Re: Indian Point Unit No. 2  
Docket No. 50-247

Subject: PWR Erosion-Corrosion Questionnaire (Revision)

PWR EROSION - CORROSION QUESTIONNAIRE

ATTACHMENT III  
HEAT BALANCE DIAGRAM

897264 KW NET LOAD  
HEAT BALANCE

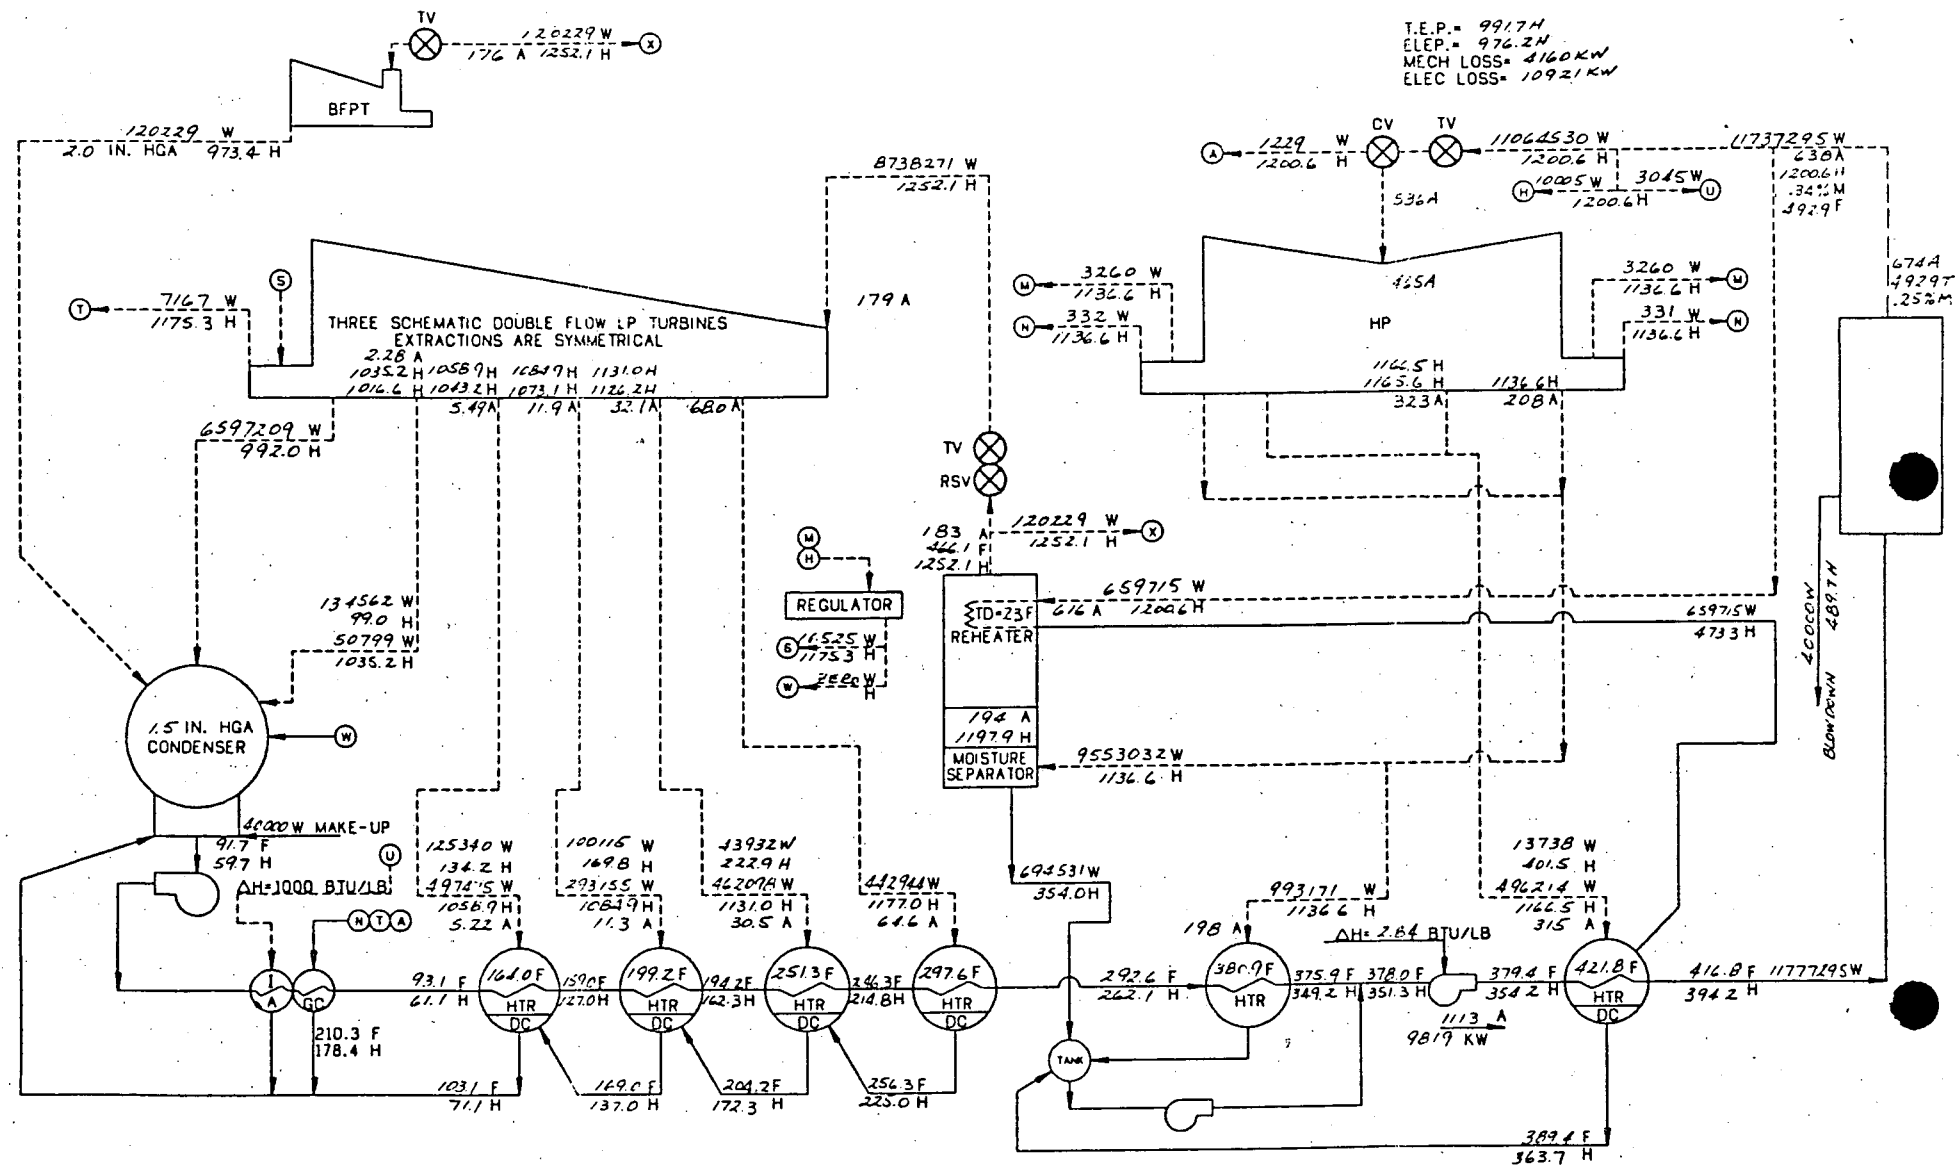
By letter dated September 18, 1987, Con Edison responded to your July 20, 1987 request that we complete a PWR Erosion-Corrosion Questionnaire. That response, in part, provided information based upon the original design reactor power for Indian Point Unit 2 (IP-2) and does not reflect current IP-2 operations. The numbers currently submitted reflect our current license limit of 2758 MW thermal (core). Accordingly, a revised heat balance diagram is provided with revised values for items B.1, B.3, and B.5.
